# Hebden Bridge Flood Alleviation Scheme

## Consultation Report September 2017

**Option 1 - Old Gate: extension of existing river wall with glass flood panels fixed on coping.**

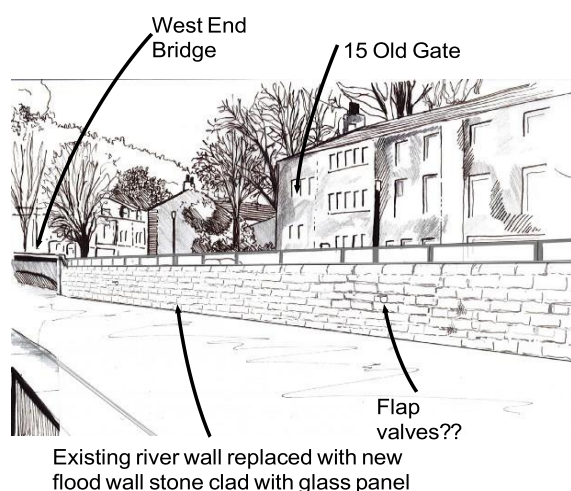
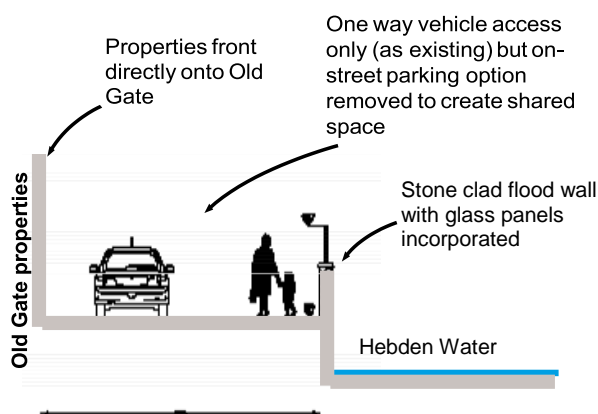
Prefer option 1 as seems a simpler and less cluttered approach. Would change the street less and retain the view.

Option 1 would be essential for us to remain in business. Much of our trade is from passing customers who either walk past or drive past. Parking, albeit narrow, is essential for customers to park outside to collect large purchased items

Preferred Option 1, people would be 'guided' down a narrow corridor as prepaid vehicle access

Prefer Option 1 for Old Gate in Hebden Bridge. The pedestrianisation has worked very well in Bridge gate and having shared space on Old Gate would create an even more enlivened centre for Hebden Bridge and increasing footfall both for the new shops in Old Gate as well as into Market Street.

For Old Gate I think option 1 is preferable because its use of the total space is more flexible, and also the proposed wall line would then follow that of the existing one on the river's edge. This proposal is an imaginative extension of the existing pedestrianisation scheme and is aligned with aspirations for a greater extension of shared space, which at least will be debated in the Neighbourhood Plan.

Do not object in principle to the installation of a glass topped wall adjacent the river with self-raising barriers at strategic points, but prefer Option 1. Option 2 would make deliveries and works along Old Gate extremely difficult as there would no longer be space for two cars to pass one another (one parked and one moving) it would also isolate pedestrians from the businesses along this street therefore affecting their trade.

**Option 2 - Old Gate: New flood wall set 1.8m back from existing river wall, with glass panelling fixed on coping.**

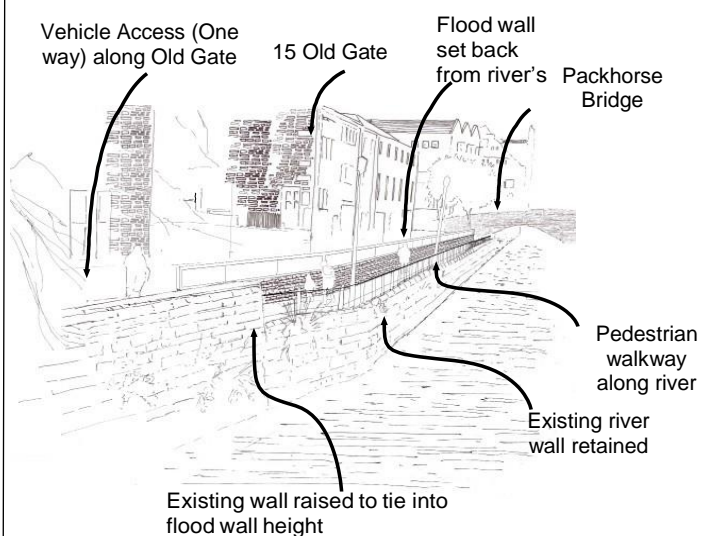
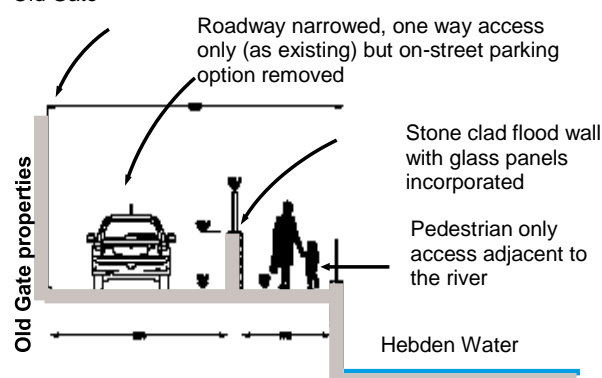
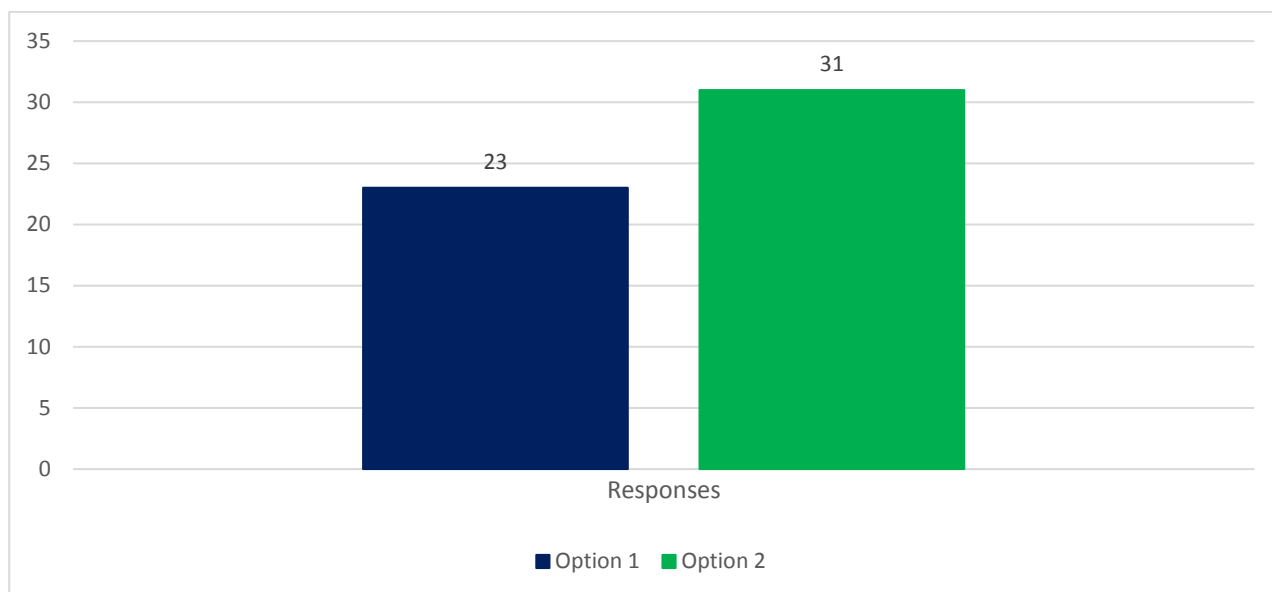
Option 2 where pedestrians are on the other side of the road would essentially stop any passing trade - pedestrians once 'on' the walkway couldn't get 'off' to call in at the shops - customers are unlikely to 'back track' down the opposite side of the road. View through the window of the shop would be limited by the glass walkway as there is already a glass barrier in front of our shops before our windows.

Option 2 is better for those with disability access issues.

The parking problem in Hebden Bridge is such a big problem that a small loss of spaces on Old Gate would not make a significant difference. (Comment on option 2)

Option 2 - Good option - so pedestrians get full river view. But only if the grass triangle just beyond Old Gate House is paved or gravelled for residents & delivery parking. Although there is no dedicated residents parking at present (& no residents permits allocated) some of Old Gate House residents pay for an annual council parking permit & rely on parking there all the time.

The option to retain the walkway, but bring the wall in – will restrict the view even further, create a rat run down Old gate and make the street feel un-safe. It will remove all walking trade from the shops – i.e. the parents who walk past the toy shop with their children will be diverted behind a large wall and by pass the shops entirely.

## Would you prefer more continuous 'glass tops' to walls or inserts of full height glass panels instead of short sections of wall?

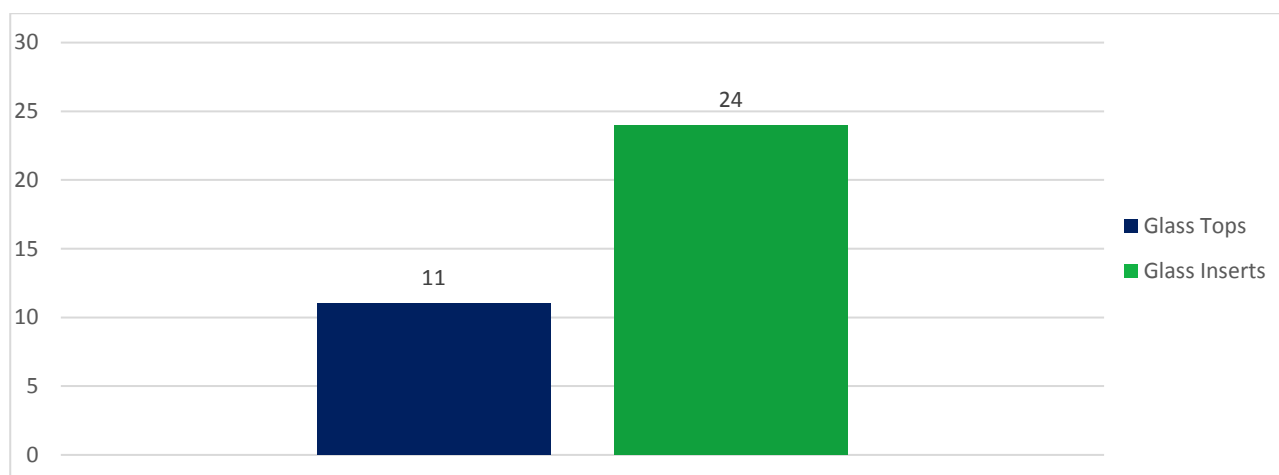
The continuous glass panels shown on top of the wall are to frame a distant landscape scale view. So might not be appropriate for Hebden Bridge where views are shorter distance and more focused.

If it is to be a choice of glass panels in a wall, I prefer the glass inserts to the glass tops, but feel that the use of glass here needs careful consideration - the flood wall shouldn't become a dominant element.

**Option 2 - Bridge Gate: Self-raising walls with fixed stone wall, showing the walls down.**

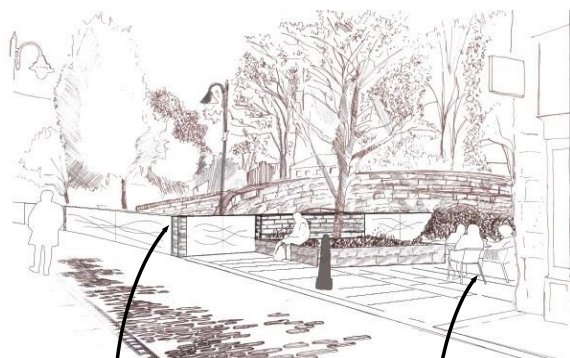
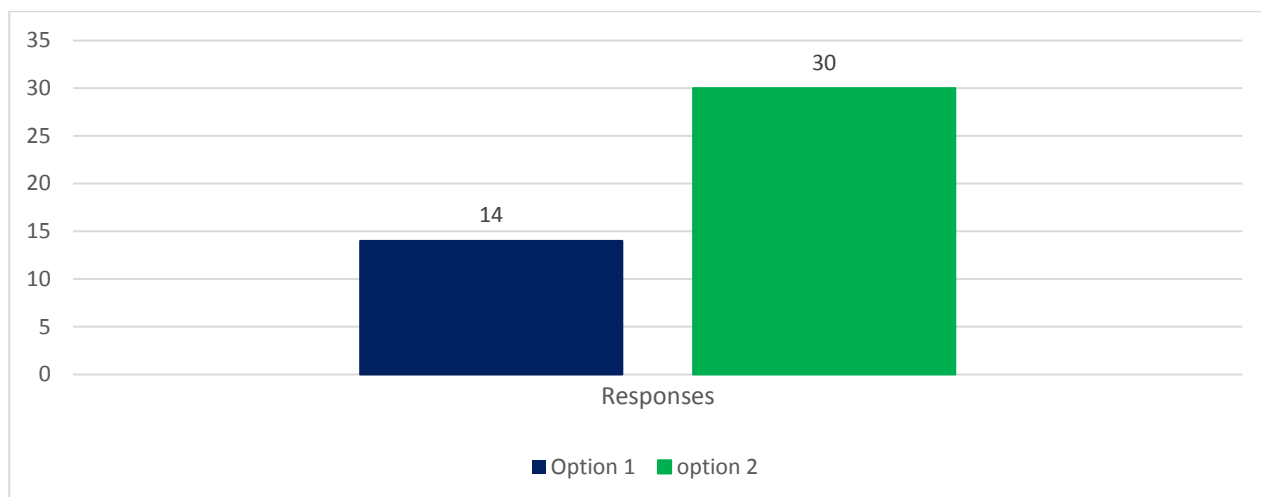
Option 1 has a wall in front of the bridge which I think detracts from the view of the bridge. Thus I prefer option 2.

It would be awful if we were to lose the trees by the river; they soften the effect of the urbanised area and disguise some of the ugly backs of buildings in Bridge Gate with all their air-cons & other systems. On balance I think I prefer option 1 for Bridge Gate.
